CVS STORE NO. 07464
SWC HORIZON RD. & RIDGE RD. (F.M. 740)
ROCKWALL, TEXAS

AS-BUILT
Winkelmann & Associates, Inc. hereby states that this plan, to the best of our knowledge is "As Built." Modifications from the originally approved construction documents have been made as per information provided by the contractor. Winkelmann & Associates, Inc. does not certify as to the correctness or quality of construction as no field inspection was performed.
Michael T. Doggett
WINKELMANN & ASSOCIATES, INC. 07-16-15 DATE

03/27/2015 CHANGE ORDER NO. 1
09/29/2014 ADDENDUM NO. 2
06/12/2014 ADDENDUM NO. 1
07/28/2014 RE-DESIGN

STORE NUMBER: 07464
SWC HORIZON RD. AND RIDGE RD.
ROCKWALL, TEXAS
PROJECT TYPE: EXTERIOR REMODEL
DEAL TYPE: FEE FOR SERVICE
CS PROJECT NUMBER: 76657

FILE NAME: 70801-Grd.dwg
JOB NUMBER: 70801.00
DATE: JULY 28, 2014
TITLE:
**DRIVEWAY
XSECT 4**
SHEET NUMBER:
C-12

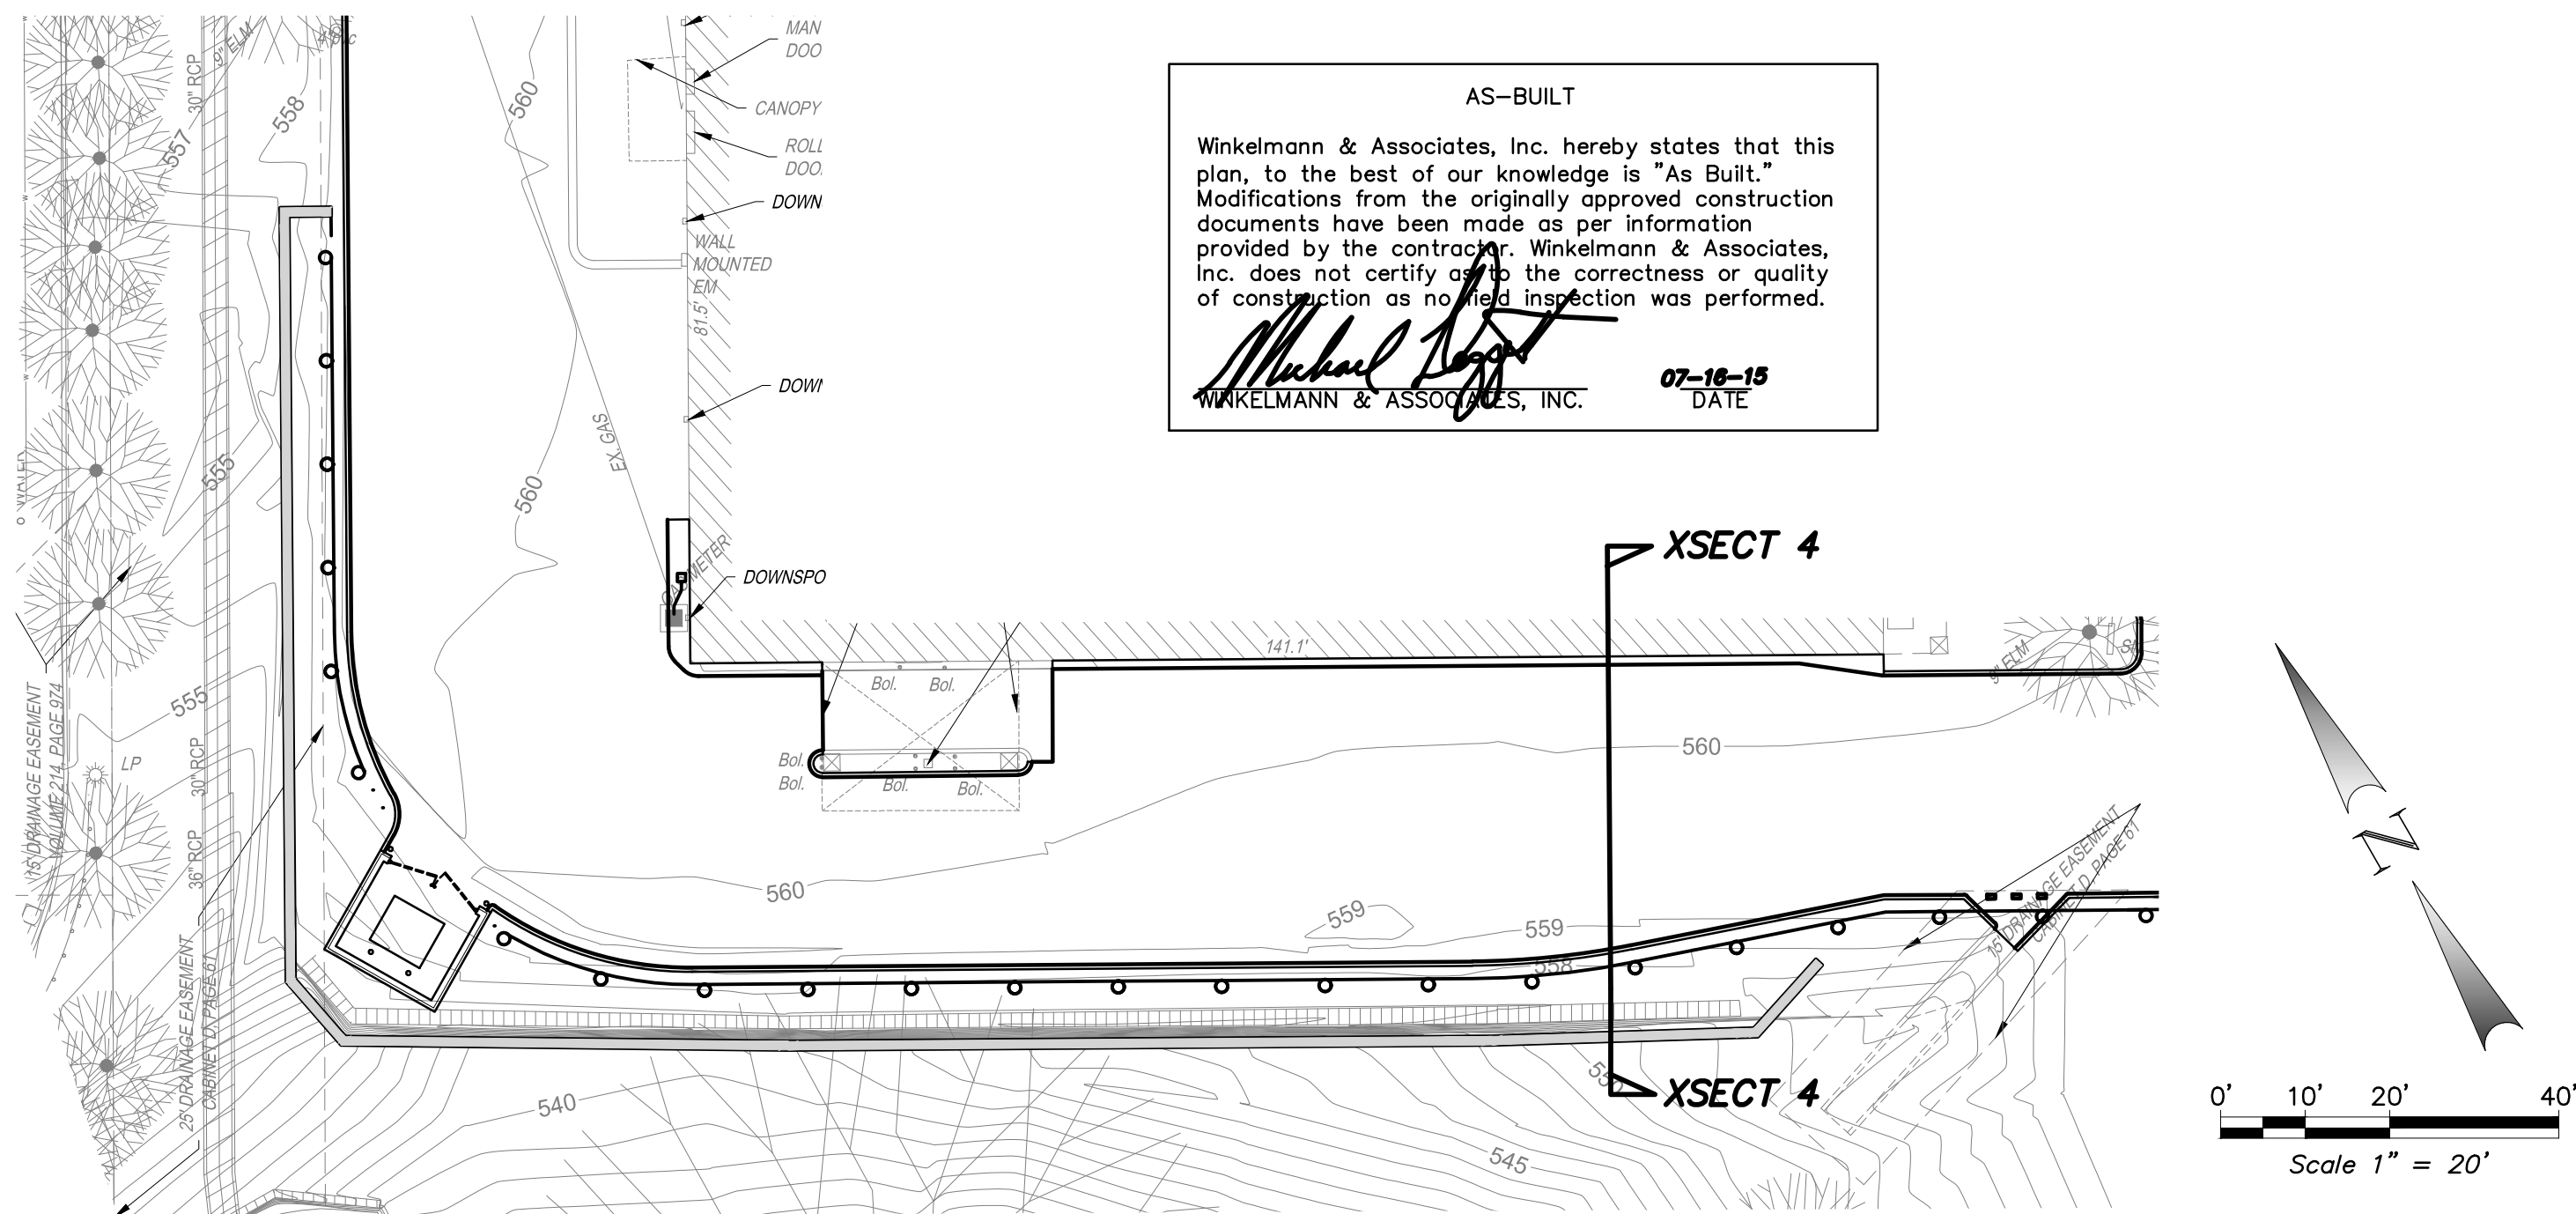
C.O. #1 ALL EXPOSED/EXTERIOR FACES/ENDS OF SHOTCRETE WALL TO BE BRICK VENEER TO MATCH BUILDING. BRICK TO BE INSTALLED PER HAYWARD-BAKER DESIGN/DIRECTION.
C.O. #1 HAND RAIL ANCHOR BOLTS TO BE LENGTHENED TO ACCOUNT FOR BRICK CAP/MORTAR THICKNESS AND PROVIDE MIN. 5" DEPTH INTO CONCRETE WALL PER TxDOT PRD-13 DETAILS ~ ANCHORING METHOD TO BE REVIEWED AND APPROVED BY OWNER'S ENGINEER AND A STRUCTURAL ENGINEER REGISTERED IN THE STATE OF TEXAS PRIOR TO MANUFACTURE AND INSTALLATION. AN ALTERNATE METHOD OF POLE ACHORAGE MAY BE PROPOSED, BUT STILL MUST BE APPROVE AS DESCRIBED ABOVE.
C.O. #1 ALL PORTIONS OF TxDOT PRD-13 TYPE "E" HANDRAIL SHALL BE PAINTED AS DESCRIBED ON PRD-13 SHEET 3 OF 3 USING TxDOT ITEM NO. 446 "CLEANING AND PAINTING STEEL". COLOR OF PAINT SHALL BE SPECIFIED BY OWNER PRIOR TO PAINTING.
C.O. #1 WALL CAP TO BE FULLY MORTARED BRICK MASONRY ROWLOCK HEADER CAP OF UNIFORM WIDTH ALONG ENTIRE LENGTH OF WALL. CAP TO MATCH WALL VENEER.
